IMS Systems, Inc.
10521 Perry Highway
Suite 310
Wexford, PA. 15090
(724) 940-7160 Main Office
(724) 940-7179 Fax

Mr. Bill Ward
Mechanical Engineer
United States Nuclear Regulatory Commission
Washington, D.C.

Enclosed is our response to the letter you sent us on 28 June, 2001. We have addressed the questions in the same order that you presented them. We hope that you find the inclusions satisfactory. Please accept our apologies for some confusion over the construction parameters and the use of German in some of the drawings. We wish to make your review of our requests as smooth as possible.

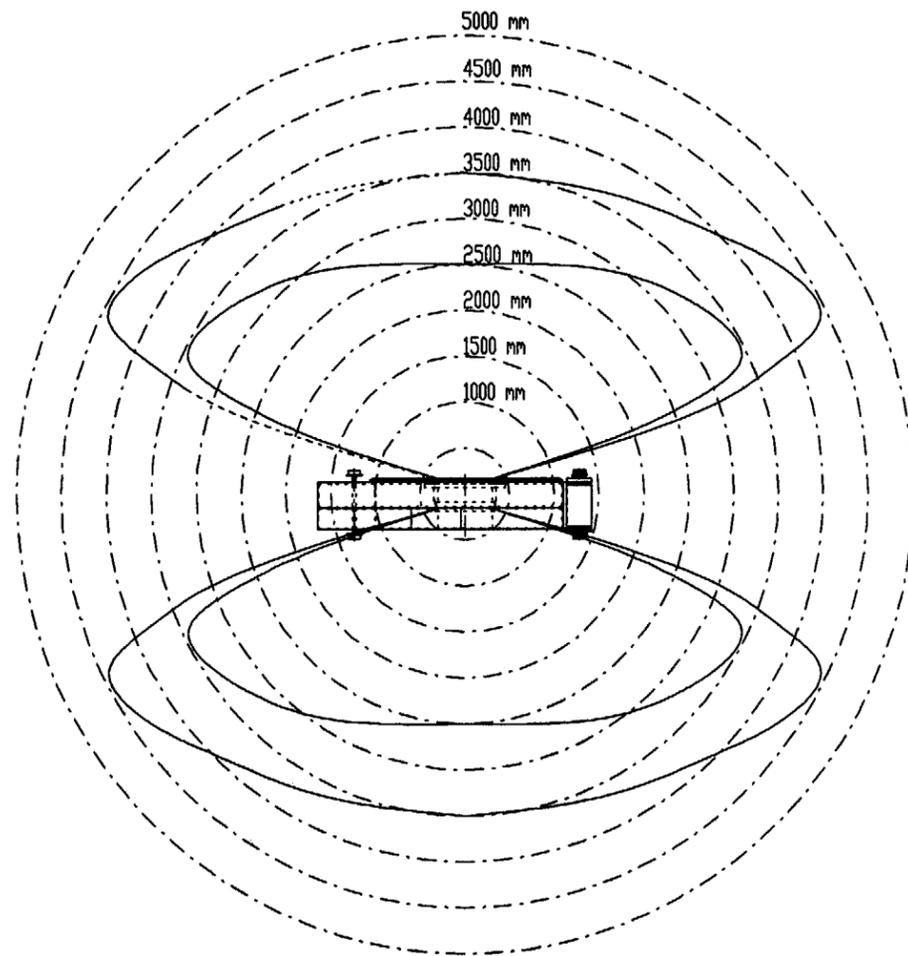
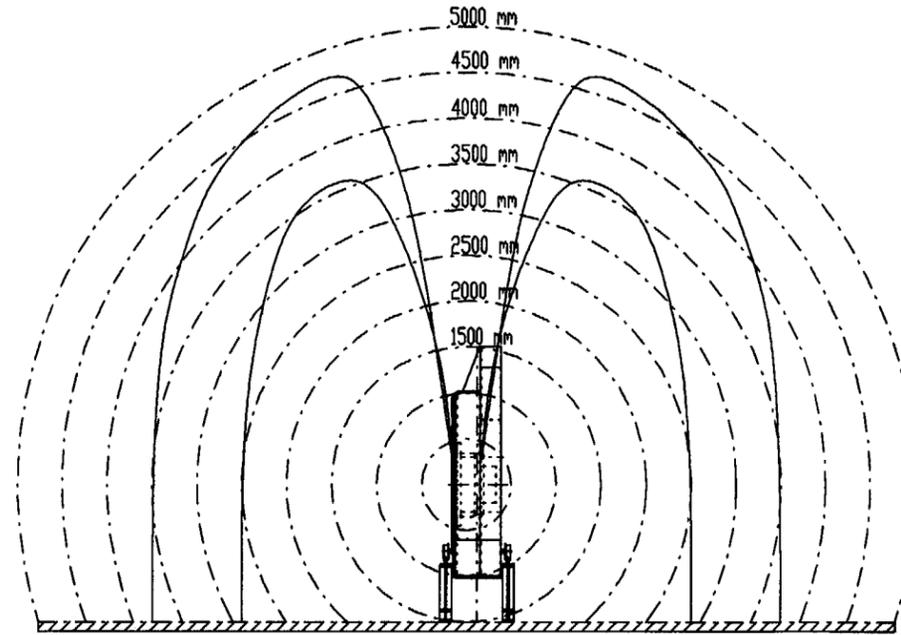
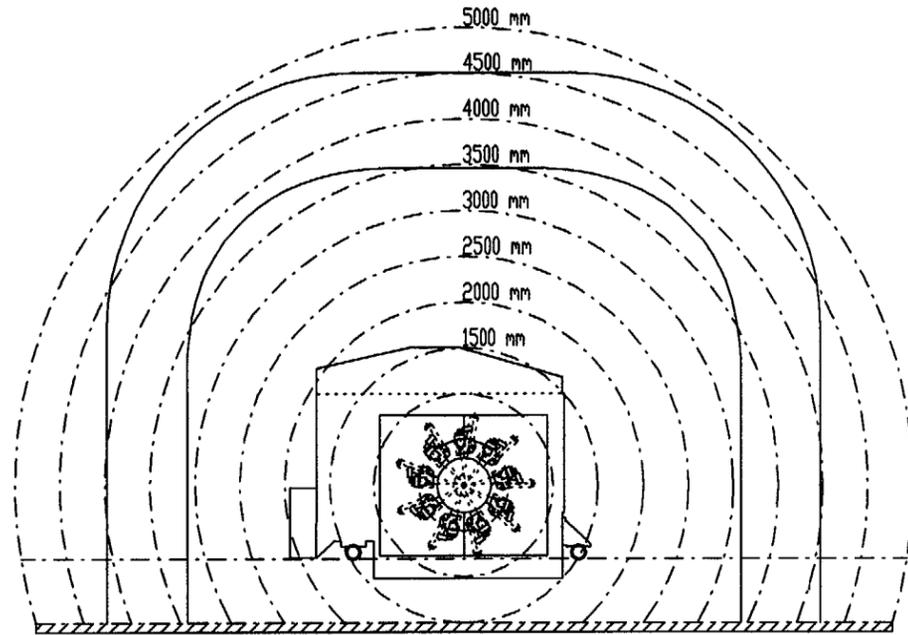
RADIATION PROFILES: Please see the attached isodose curves that are actual measurements around the gauge. As noted on page five of the ANSI testing section of the application, measurements were taken with a Babyline 31 system. The absorber information is:

There is no external dose when the shutter is closed. The exposure in this configuration is confined to the "O" part of the frame.
